FOUNDATION INSPECTION

8139 Silent Deep Dr
Rosenberg, TX 77469

5: FOUNDATION ANALYSIS

Approximate area in need of repair.

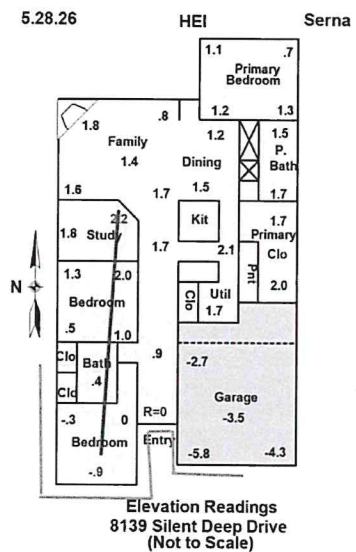
Most of the structures previously inspected by this firm have experienced some degree of differential foundation movement, and this structure was no exception. After careful examination, the engineering analysis above showed that the degree of the foundation movement **is more than what is acceptable by the standards set forth by the American Society of Civil Engineers**. The most significant movement was located at the south.

Due to the more than acceptable amount of movement of the foundation of this structure, **the foundation needs to be releveled**. It is recommended that at least **three foundation repair contractors** be contacted in order that they may make their own assessment of the scope and cost of the work needed to bring this foundation back to an acceptable degree of levelness. Each foundation repair contractor should provide their own design proposal showing the types of piers to be used to underpin the foundation, the number of piers, and the pier locations, along with their warranty information. Note that HEI does not prepare or approve foundation repair designs due to a multitude of potential engineering, legal, and/or ethical issues.

Contact a foundation contractor.
